MAPA Meeting - April 28, 2020

Recent and Upcoming Policy Changes

HEIGHT AND LATERAL LOCATIONS FOR POST AND PORTABLE SIGN MOUNTING

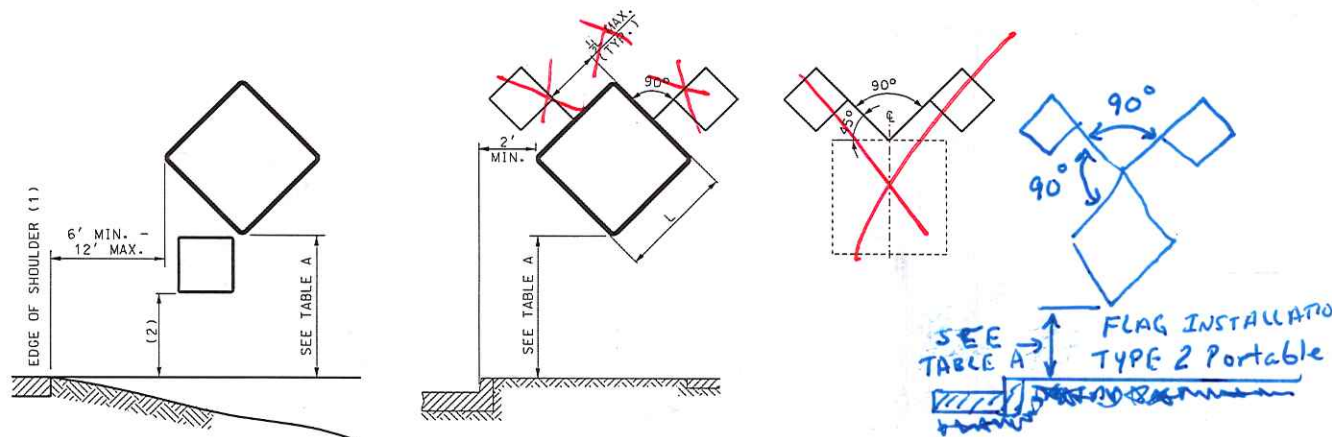
6. Revisions to EPG 616.6.2.2 and Std Plans. 616.10 and 903.03. Revisions include: flags are only required on on first ROAD WORK AHEAD signs on daytime short durations projects, and all FLAGGER AHEAD and TRUCK CROSSING signs; sign area has been increased from 30 SF to 32 SF, allowing Point of Presence and Focus on Bridges sign to use 3 U-channel posts. The u-channel post installation is also being revised. (See standard plans at end of this document.)

GOES WITH #6

Detail change on Std.
616.10 sheet 2

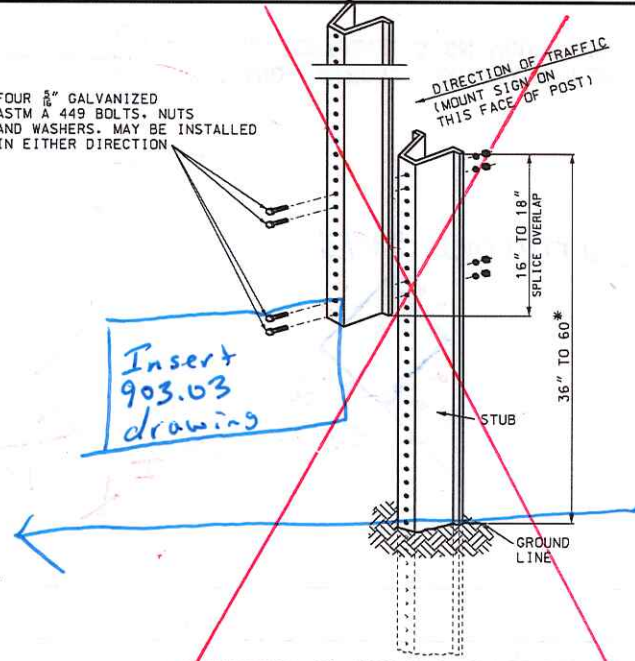
U-CHANNEL POST DETAIL
OPTIONAL INSTALLATION

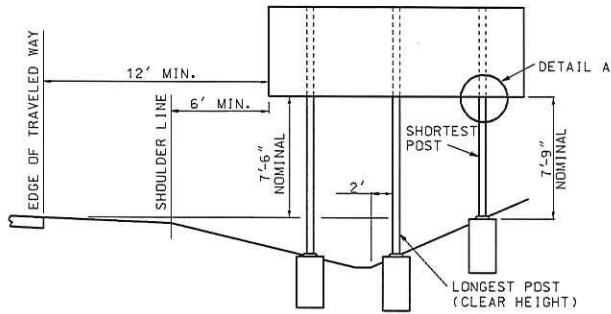
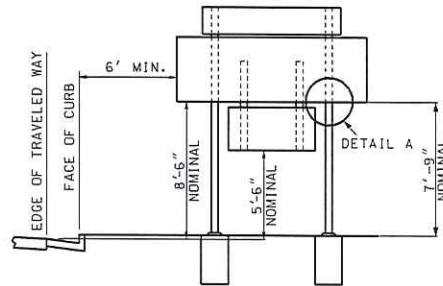
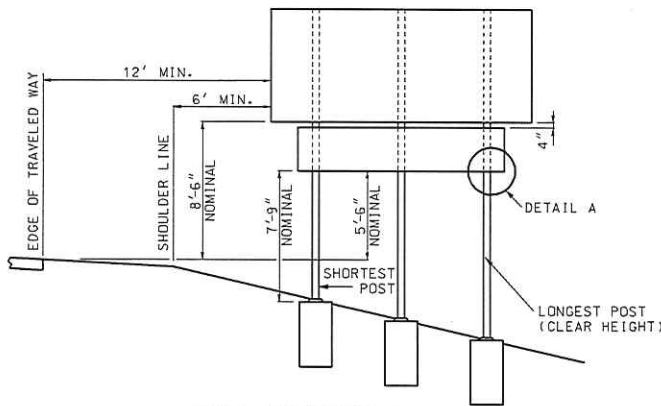
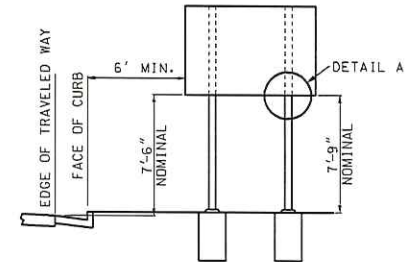
*Add drawings to sheet
616.10 pg 2 of 9*
